STATE SIGNIFICANT DEVELOPMENT ASSESSMENT REPORT:

**Stages 2B and 2C (SSD 5346), 2D (SSD
5347) and 3B (SSD 5349) of the North
Penrith development site**

Infrastructure, Landscaping and Subdivision

**Director-General's
Environmental Assessment Report
Section 89H of the
*Environmental Planning and Assessment Act 1979***

Figure 7: 200 year ARI flood depths and velocity vectors (Source Worley Parsons, Regional Flooding Assessment 2010) (regional FPL RL 26.3m AHD)

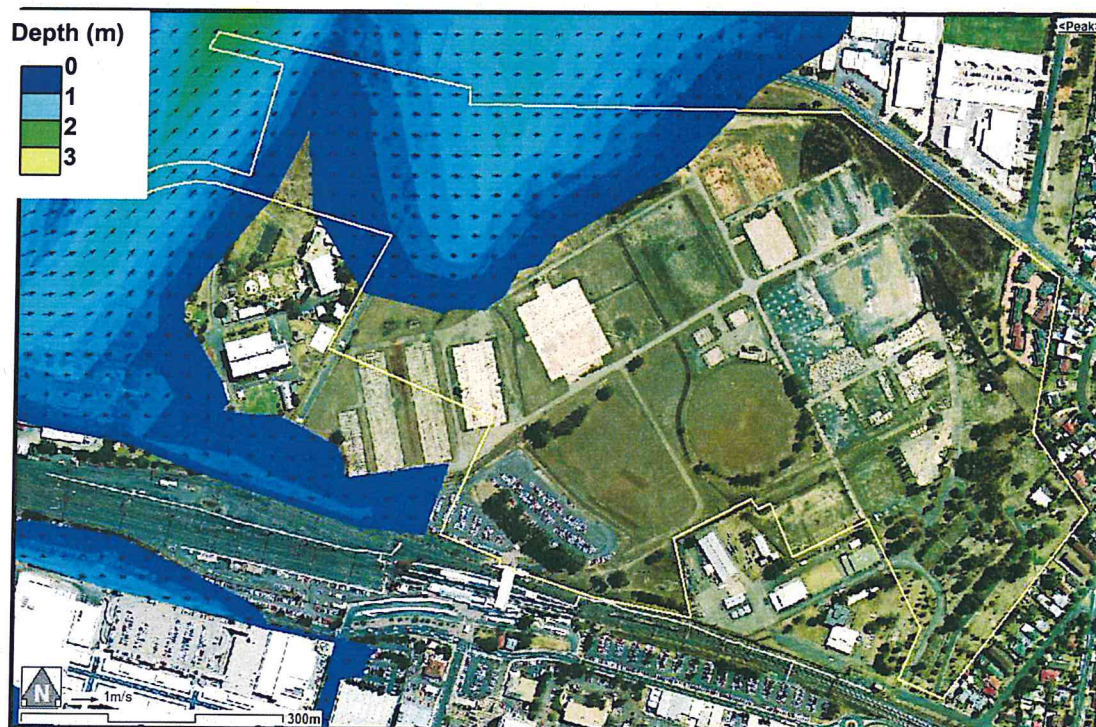
engineer identified that the FPLs approved in the Concept Plan for the North Penrith development site had been set too low. However, as the flood modelling considered for this exercise was undertaken over a large area, the implications for the North Penrith site affected cannot be accurately determined at this stage. The department and OEH are of the view that a relative level of 25.8m AHD is likely to be the appropriate flood level for the North Penrith site i.e. 400mm higher than the presently approved level. As the base data required in order to undertake the modelling is as yet unavailable, the precise FPL specific to this site is unknown. Visually, the new probable FPL is between the 100 year and 200 year ARI flood depths illustrated in Figures 6 and 7.

Nevertheless, the department must take a precautionary approach to setting flood planning levels for this site and requires the applicant to take into account the latest data available from outputs from the PLDC flood modelling and the council's RMA Regional Flood Model that will be finalised subject to incorporation of the approved Penrith Lakes end-state landform. Whilst council's RMA Regional Flood Model is likely to take some time to be finalised, the department recommends the applicant be required to determine an appropriate FPL using this information prior to the issue of subdivision certificates. In this way, the applicant is able to commence construction on the site whilst refining the final levels for that small part of the site likely to be affected. Importantly, no future housing can be constructed until such time as the appropriate FPL has been established.

**Figure 10: Stage 2B (SSD 5346) Proposed Subdivision – including
The waterways being the canal and wetland, 1 industrial lot and
2 residential flat building lots**

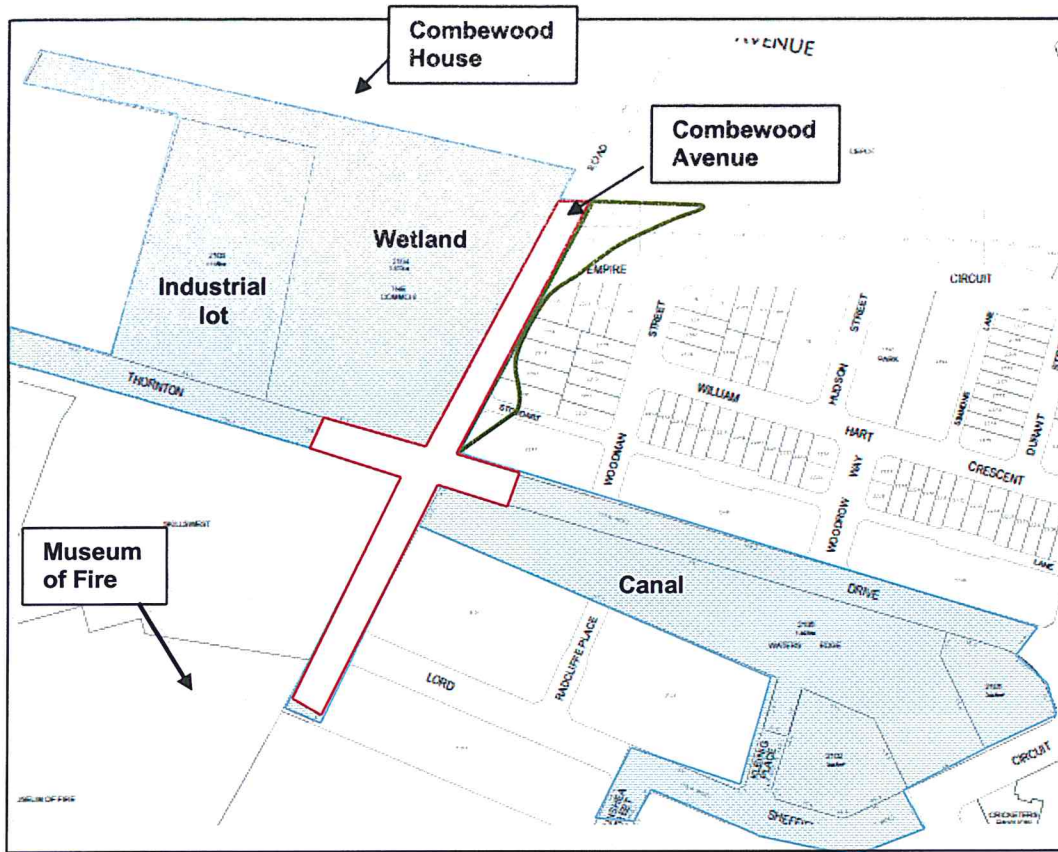
RLs 25.5m to 26m AHD within residential areas

Road not complying with new probable FPL of RL 25.8m AHD

Figure 19: Intersections Requiring Works under the Concept Plan
Intersection No. 1 is relevant to the Stage 2B & 2C (SSD 5346) proposal

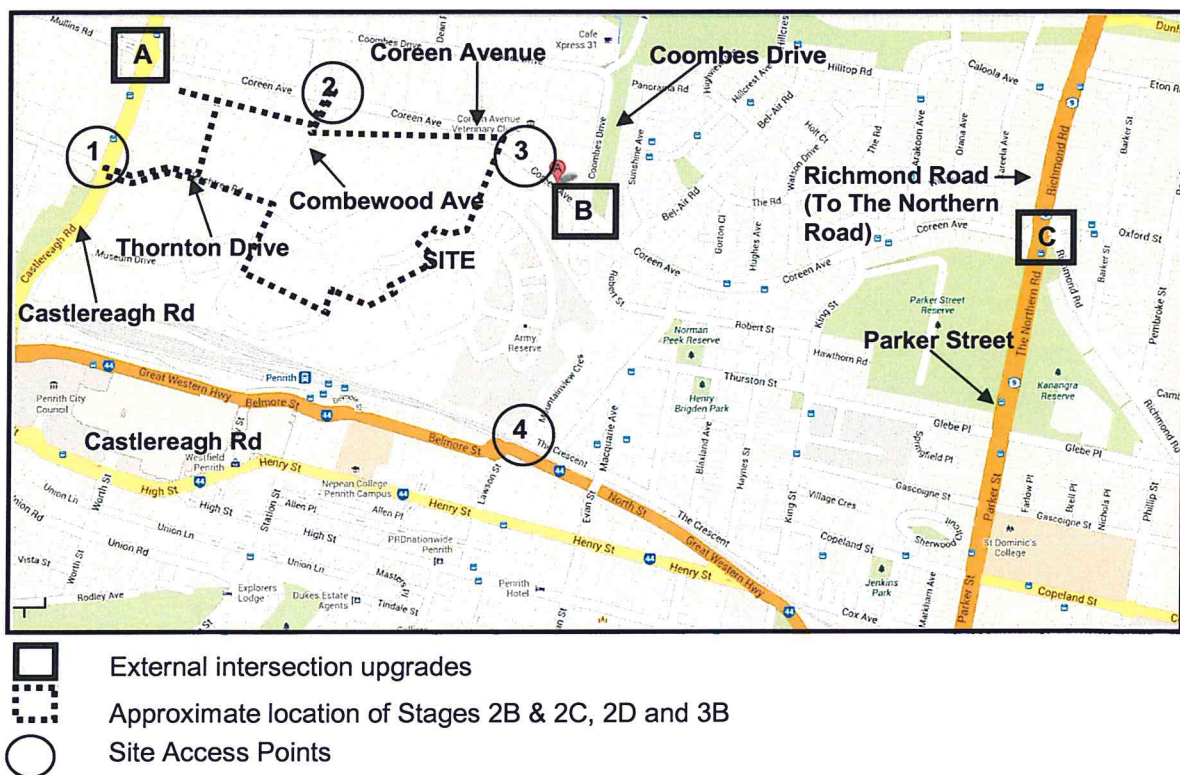
The Concept Plan 'further environmental assessment requirements' specifically require a detailed design of the intersection of Castlereagh Road and Thornton Drive (formerly Grace Drive) be submitted within the Stage 2C application (see Figure 19 intersection No. 1).

A design for this intersection was provided in the Stage 2B and 2C EIS however submissions from Council and RMS requested that the right turn bay length on Thornton Drive turning into Castlereagh Road, be amended to maximise capacity.

Council requested the creation of a right hand turn bay from Richmond Road into Coreen Avenue (see Figure 19 intersection No. C) and the installation of a seagull treatment on Coreen Avenue at the eastern intersection with Coombes Drive to be constructed 'upfront'.

Figure 20: Approximate Proposed Lengths of Right Turning Bay from Grace Drive

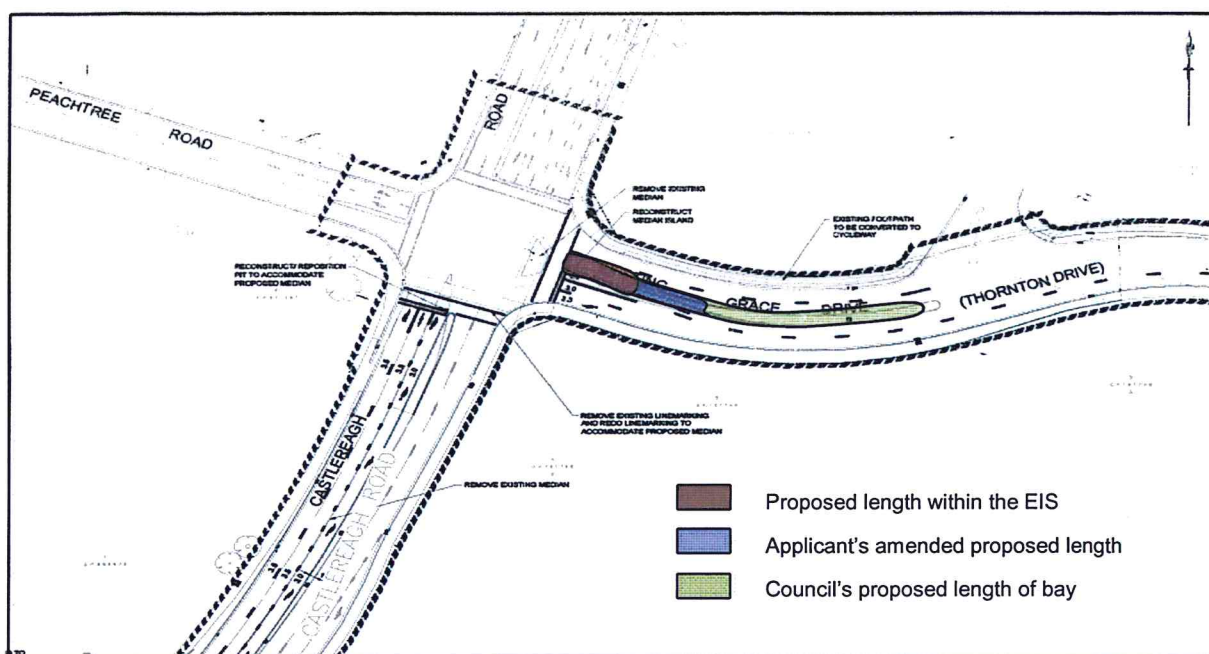
In the 'Response to Submissions' the applicant provided an extension to the right turn bay however the extension provided was shorter than Council requested. Council has again requested the capacity of the bay be extended further (see Figure 20).

Figure 20 indicates the length of the right turn bay on Thornton Drive as proposed in the EIS, the extension the applicant proposed in response to both Council and RMS submissions and the length of bay Council would like to see constructed.

Further consultation confirmed Council considered the proposed lane marking to be confusing and a longer right turn bay would protect against queuing overflow.

The applicant states that Council's request is inconsistent with the original Concept Plan, the revised design has been agreed by RMS and that Council is to meet any additional costs of increasing the scope of works.
